NEW YORK STATE THRUWAY AUTHORITY
DEPARTMENT OF ENGINEERING

AMENDMENT NO. 2
TO

CONTRACT TAS 24-20B
D214978
REPLACEMENT OF THE I-90 BRIDGE OVER
ORISKANY BOULEVARD (NY 69) AT MILEPOST 238.22
IN THE SYRACUSE DIVISION
OF THE NEW YORK STATE THRUWAY
IN ONEIDA COUNTY

TITLE OF PROJECT REPLACEMENT OF I-90 BRIDGE OVER ORISKANY BOULEVARD	CONTRACT NUMBER: TAS 24-20B
LOCATION OF PROJECT SYRACUSE DIVISION MP 238.22	DATE: 04/03/2024
TITLE OF DRAWING INTERIM STEEL SHEETING WALL PLAN AND ELEVATION WESTBOUND REPLACEMENT	DRAWING NUMBER: ST-8

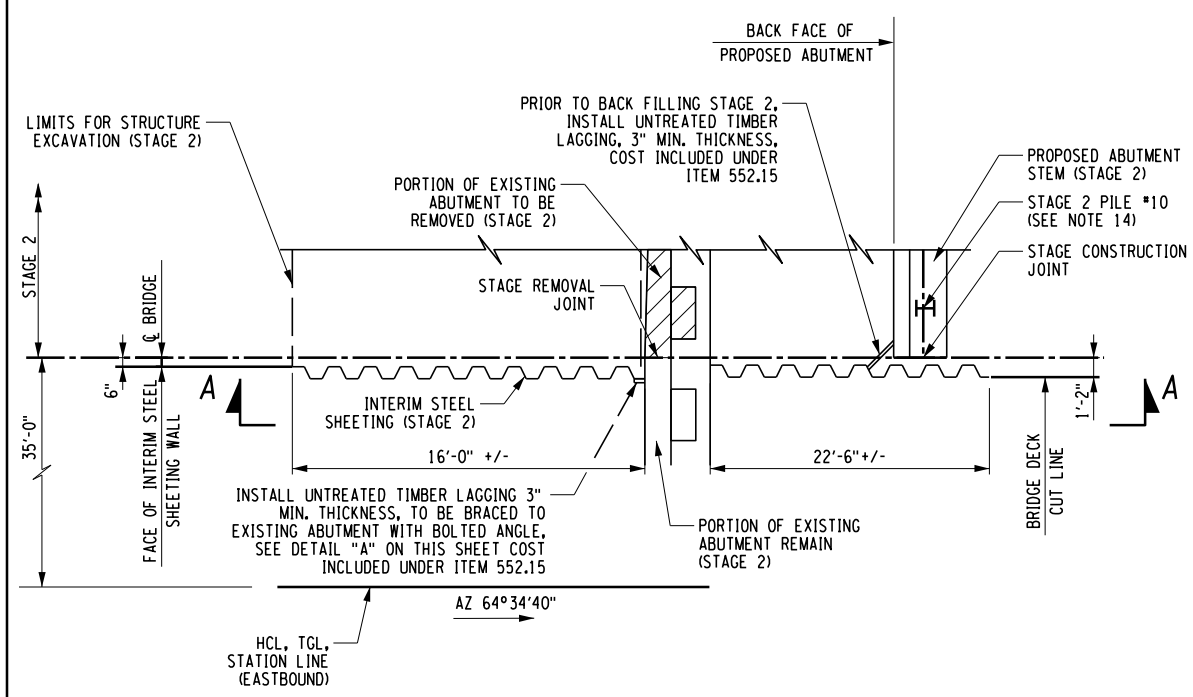
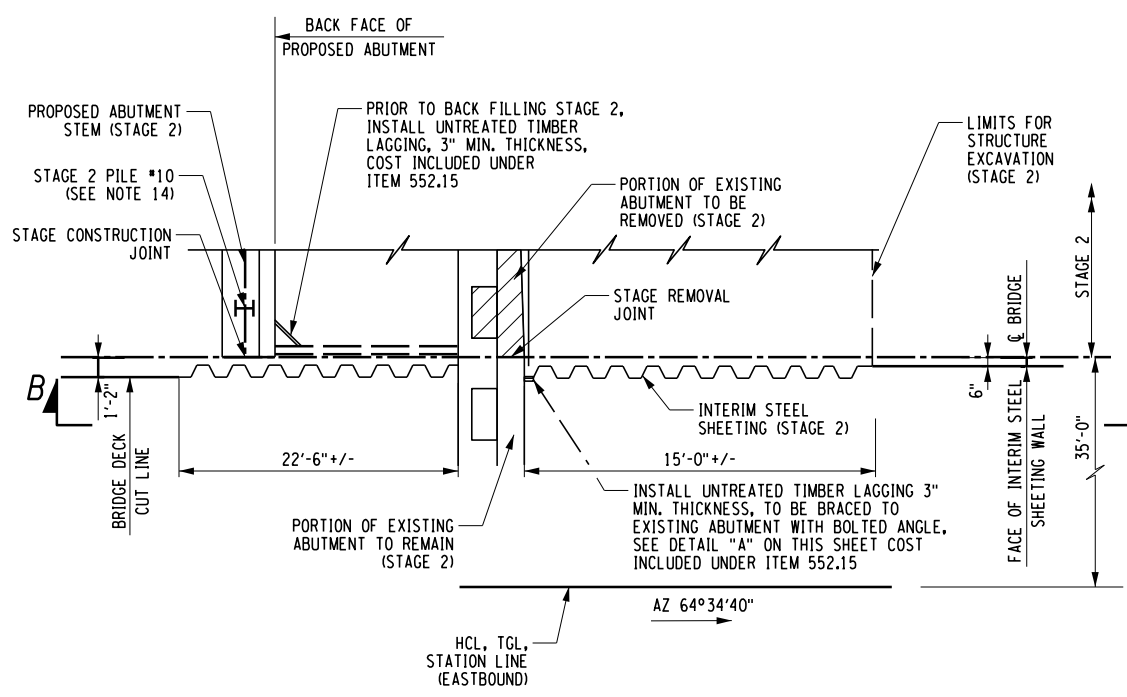
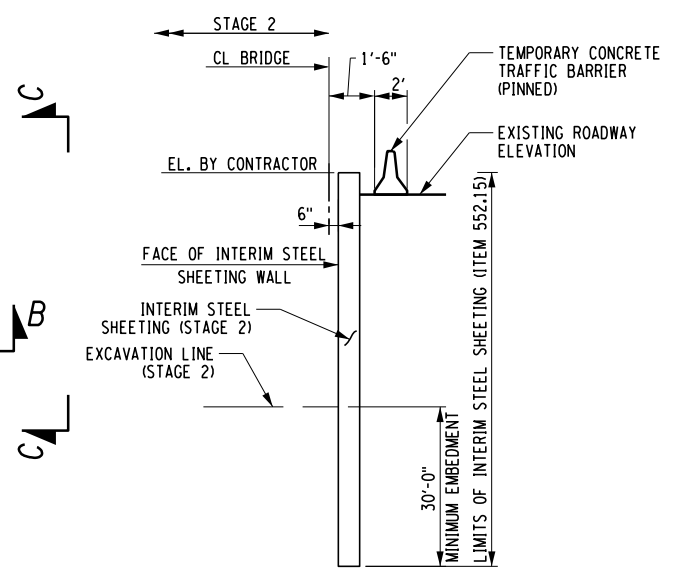
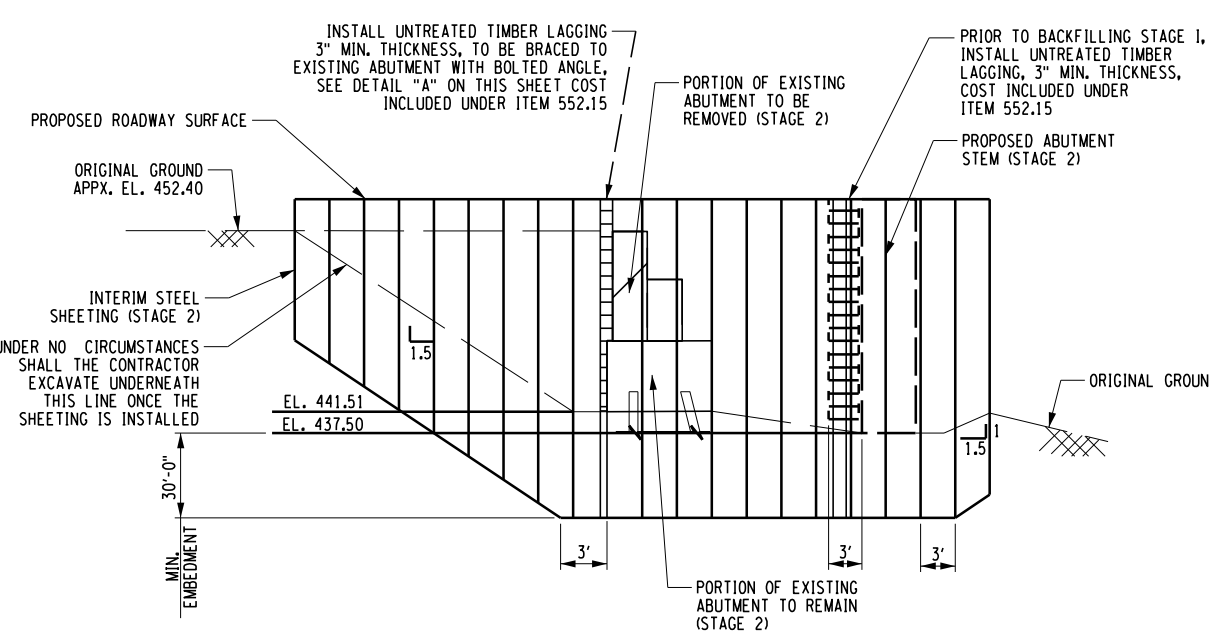
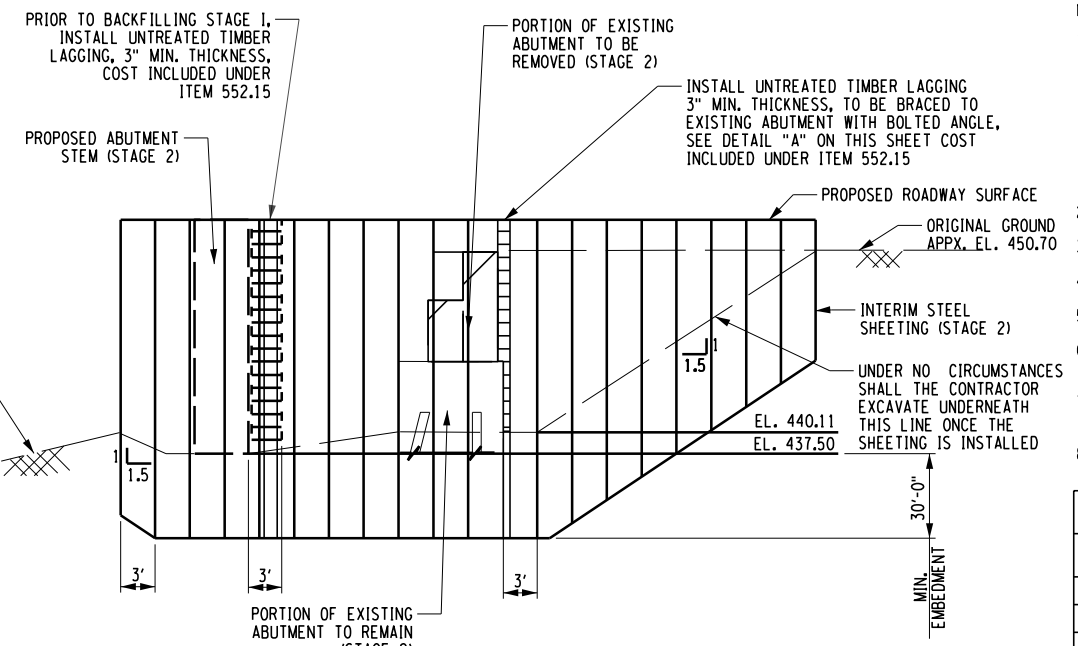
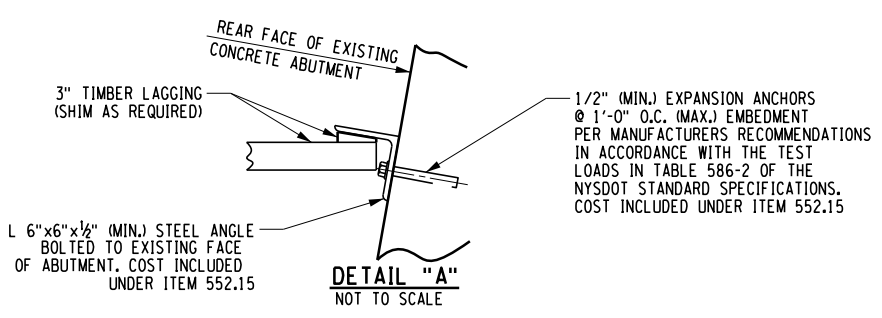
1. **DELETE** Drawing ST-6, Sheet 67, and **SUBSTITUTE** with the attached Drawing ST-8, Sheet 67A2.
Note 3 was revised to require a minimum section modulus of 78.00 in³/ft instead of 89.28 in³/ft for the steel sheet piling.

- THE STEEL SHEETING SHALL CONFORM TO ASTM A572, GRADE 50.
 - THE MINIMUM SECTION MODULUS OF THE STEEL SHEETING SHALL BE 78.00 IN³/FT.
 - THE MAXIMUM DEPTH OF EXCAVATION FOR THE STEEL SHEETING IS 15 FEET.
